Re: Peer Review of the Traffic Impact Analysis Prepared for the Townhomes at Laurel Knoll (Subdivision #9263)

PEER REVIEW

Laurel Knolls TIA

FIGURE 1 | PROPOSED CHANGES TO PAVEMENT MARKINGS

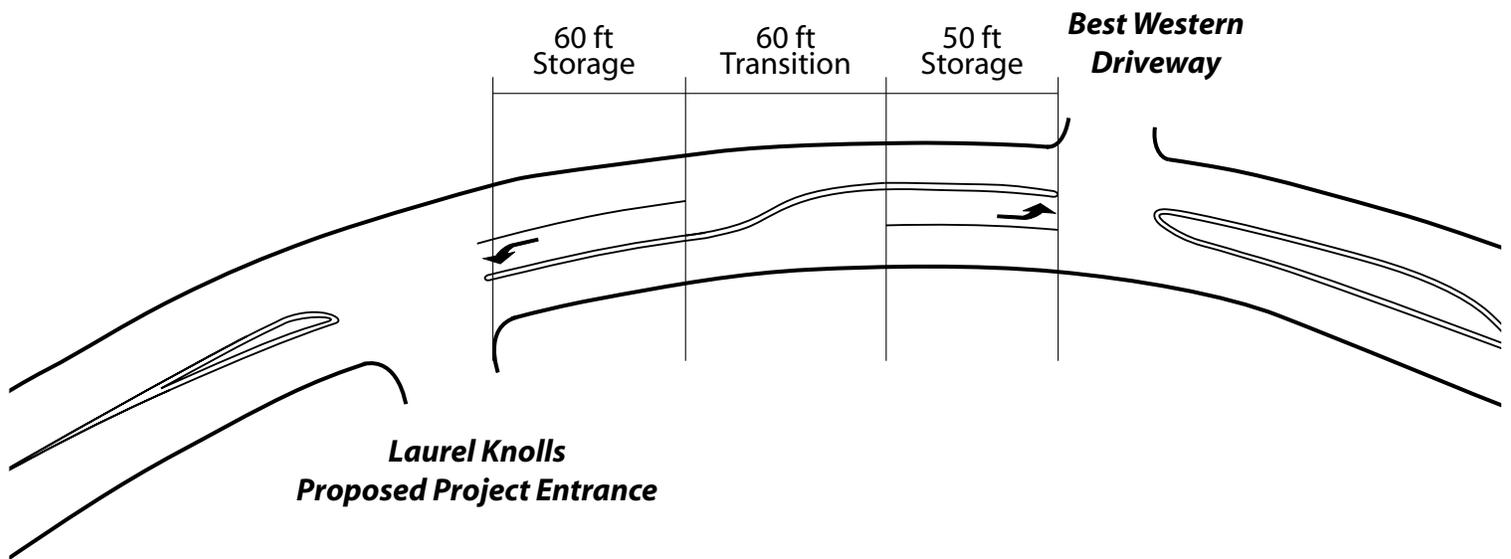
Suggested Changes to Pavement Markings on Muir Station Road – Although not required to address any impacts of the proposed project, our review indicates that with the addition of project traffic some changes to the pavement markings on Muir Station Road may be considered, although these are not necessary.

The attached Figure 1 presents the existing conditions and our suggested changes to the pavement markings on Muir Station Road. Please note that we have reviewed the potential queuing for the left turn pockets presented in Figure 1 and the minimum left turn pocket storage of 50 feet (as specified by Caltrans standards) is all that would be required for these two turn pockets. For example, the existing left turn pocket for the left turn from westbound Muir Station Road into the adjacent shopping center has 50 feet of storage and a 40 foot transition.

Section 405.2 of Caltrans' Highway Design Manual specifies that the storage length at an unsignalized intersection "*may be based on the average number of turning vehicles likely to arrive in a 2 minute period.*" Based on the maximum hourly volumes forecast to use the two turn pockets (as presented in Figure 1) the proposed storage for two cars (50 feet) is the most that will ever be needed. Again, it is important to note that the existing two-way left turn lane should continue to operate safely and no changes are required to accommodate project traffic. However, we would suggest the City consider making the changes to the pavement markings shown in Figure 1 if the proposed project is approved.
